Access Compliance Report Public Rights-of-Way (Curb Ramps)

Intersection ID: N/A	Main Street: TRYON_ST	Cross Street: I-485	Location: E
ADA ID: B0CC526DDBF1	Ramp Type: ParaDiag	Initial Pass/Fail: Fail	Overall Compliance: No Severity Score: 13.75

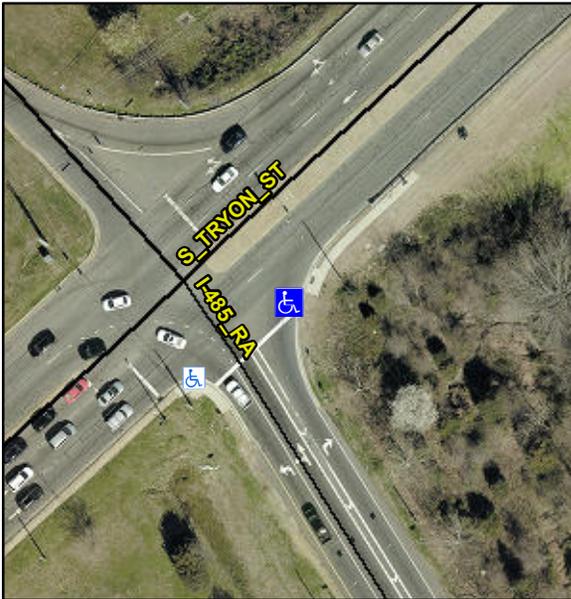
LT RP < 5%

R304.3.2, R304.5.3

Compliance	Description	Data	Compliance	Description	Data
N/A	Ramp Length LT (in)	58.0	N/A	Ramp Length RT (in)	55.0
Yes	Ramp Width LT (in)	60.0	Yes	Ramp Width RT (in)	60.0
Yes	Ramp Slope LT (%)	4.1	No	Ramp Slope RT (%)	8.4
Yes	Ramp XSlope LT (%)	1.7	No	Ramp XSlope RT (%)	2.5
N/A	Landing Length (in)	N/A	N/A	DWS Provided?	N/A
N/A	Landing Width (in)	N/A	N/A	DWS Contrast?	N/A
N/A	Landing Slope (%)	N/A	N/A	DWS Length (in)	N/A
N/A	Landing X Slope (%)	N/A	N/A	DWS Full Width?	N/A
N/A	Landing Curb? (Y/N)	N/A	N/A	DWS Offset (in)	N/A
N/A	Shared Landing?	N/A			
N/A	Gutter Ponding?	N/A	N/A	Gutter Slope (%)	N/A
N/A	Gutter Lip Ht (in)	N/A	N/A	Gutter X Slope (%)	N/A
N/A	Painted X Walk1?	No	N/A	Painted X Walk2?	No
	X Walk 1 Direction	To NW		X Walk 2 Direction	To SW
N/A	X Walk 1 Width (in)	N/A	N/A	X Walk 2 Width (in)	N/A
	X Walk 1 Slope (%)	2.4		X Walk 2 Slope (%)	2.8
	X Walk 1 X Slope (%)	1.3		X Walk 2 X Slope (%)	2.3
N/A	Ramp inside XWalk1?	N/A	N/A	Ramp inside XWalk2?	N/A

Remove & Replace Curb Ramp With Two New Directional Ramps or Equivalent.
